Project	IEEE 802.16 Broadband Wireless Access Working Group < http://ieee802.org/16 >
Title	Stuff, the sequel
Date Submitted	2002-10-24
Source(s)	Nico van Waes Nokia Wireless Routers
Re:	IEEE LMSC Sponsor Ballot recirculation of P802.16a/D5
Abstract	Proposed material referenced by submitted comments.
Purpose	Adoption
Notice	This document has been prepared to assist IEEE 802.16. It is offered as a basis for discussion and is not binding on the contributing individual(s) or organization(s). The material in this document is subject to change in form and content after further study. The contributor(s) reserve(s) the right to add, amend or withdraw material contained herein.
Release	The contributor grants a free, irrevocable license to the IEEE to incorporate material contained in this contribution, and any modifications thereof, in the creation of an IEEE Standards publication; to copyright in the IEEE's name any IEEE Standards publication even though it may include portions of this contribution; and at the IEEE's sole discretion to permit others to reproduce in whole or in part the resulting IEEE Standards publication. The contributor also acknowledges and accepts that this contributi

Replace Figure 128ax with:

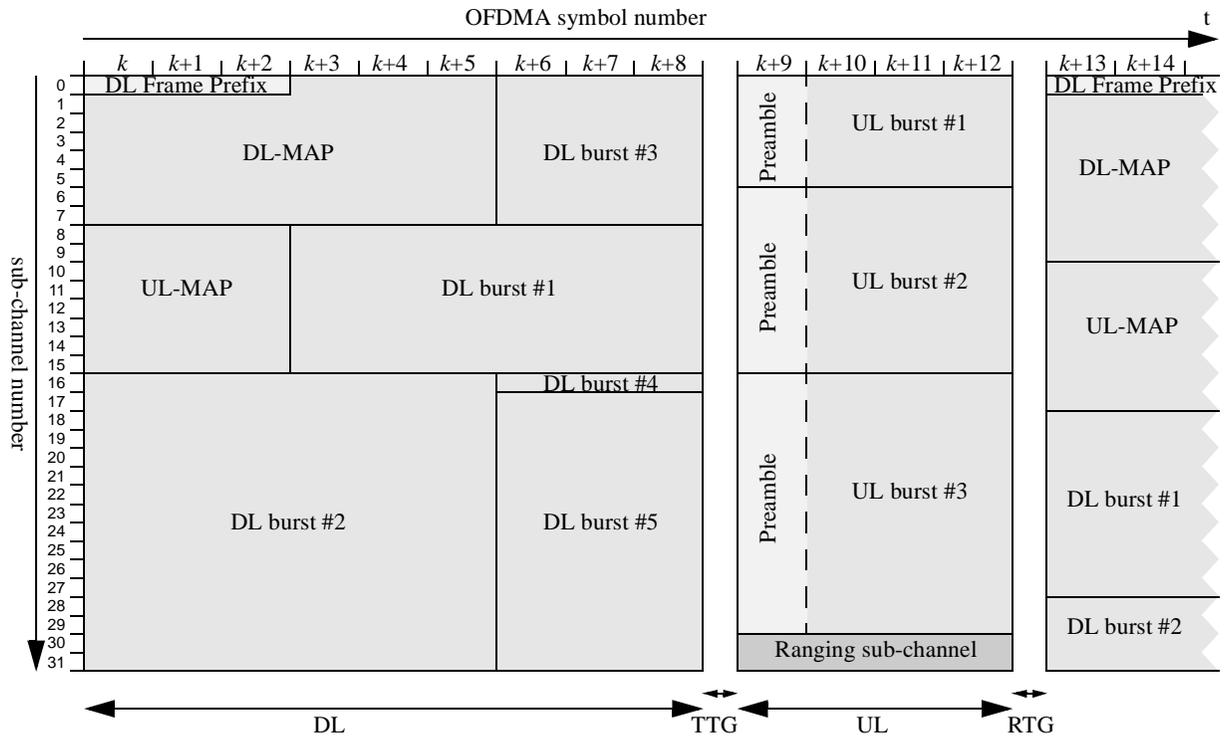
Delete 8.4.11.2.2 header and move text, minus first sentence to 8.4.3.6.
